RE: Airespace FCC ID: **QTZWN1200ABG**

Tim,
Below are the replies to your inquiries regarding this application. If something is unclear, or if you have additional concerns, please contact me.

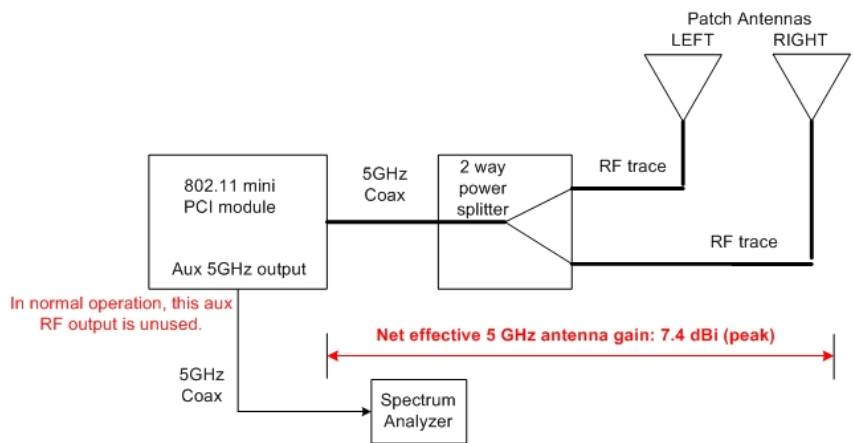
ATCB 14) The power measurement diagram does show the splitter and takes this into consideration in the calculations. However, the diagram does not appear to show the switch for the 5 GHz path. It is therefore uncertain if this was factored in as shown in the 2.4 GHz data. Additionally the switch only appears to be in one of the 5 GHz paths. (See Block Diagram). Please explain.

Airespace: The device in the RF path is a power splitter, not a switch. Recall that the 5 GHz power is split between two antennas to produce an omni directional pattern. The RF switch in earlier versions has been removed. If a version of the access point is certified for use with external 5 GHz antennas in the future, the external antennas will be connected to the AUX output of the RF module and the antenna switch function will take place on the RF module. The 5 GHz RF block diagram is to the right.
